NOTICE
OSHTEMO CHARTER TOWNSHIP
PLANNING COMMISSION

Thursday,
August 27, 2015

Request: Special Exception Use and Site Plan Review for modifications to the Lillian Anderson Arboretum

Subject: Lillian Anderson Arboretum, W Main St, SPR.

1 LIMESTONE FINES TRAIL
SCALE: 1/2" = 1'-0"

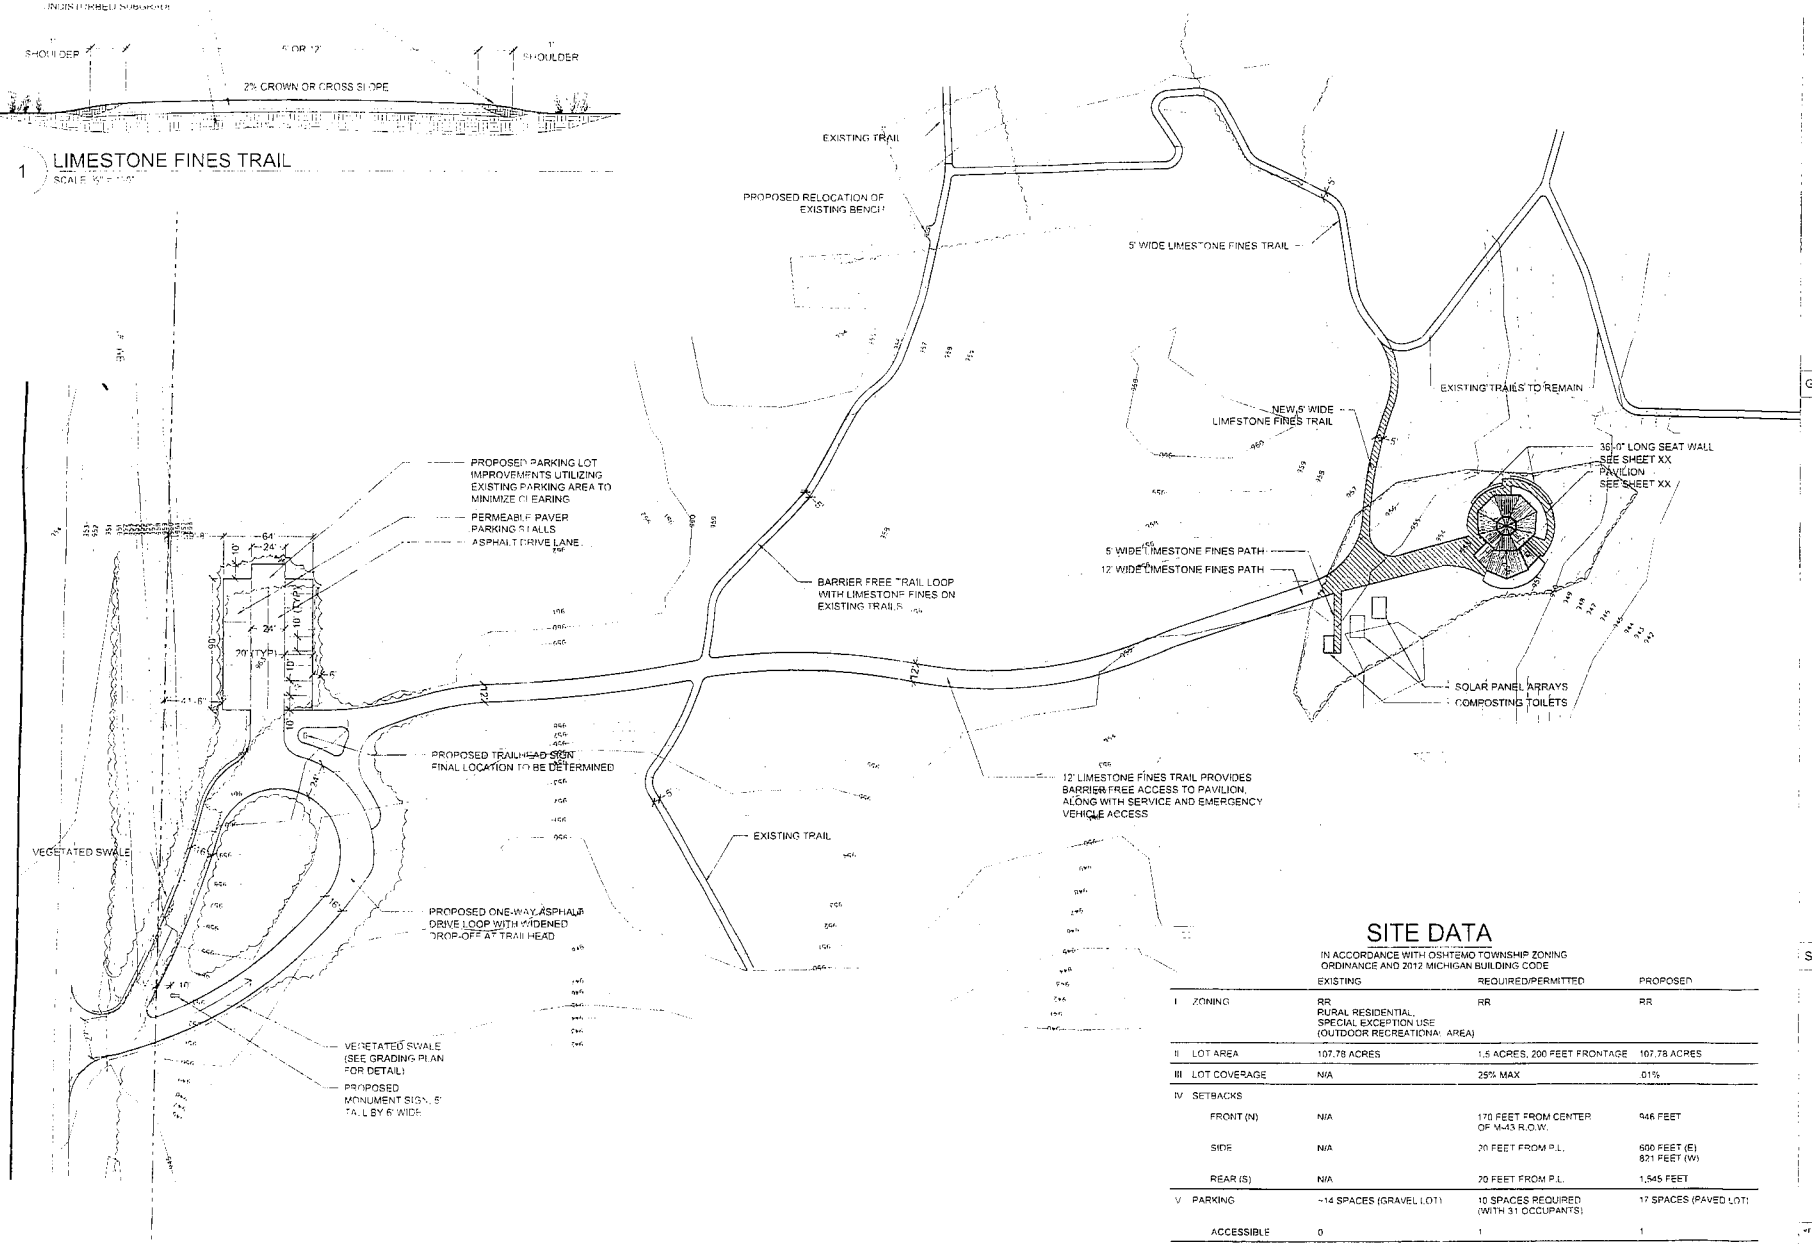
9. **Can you provide additional details on the type of permeable parking pavers you are going to be using and the maintenance that will be required?**

Asphalt porous paving is currently planned for the parking stalls, with conventional asphalt paving for the drive lanes and natural storm water management features to treat runoff as identified on the site plan. The maintenance required for asphalt porous paving includes periodic inspections to ensure that water is still infiltrating adequately, removal of debris and sediment to prevent clogging of the paving matrix, and annual use of vacuum truck to remove debris. Kalamazoo College does have porous concrete on campus and is familiar with its required maintenance. Due to cost concerns within the project, the College will be including a bid alternate for standard asphalt for the entire lot, which would eliminate permeable paving.
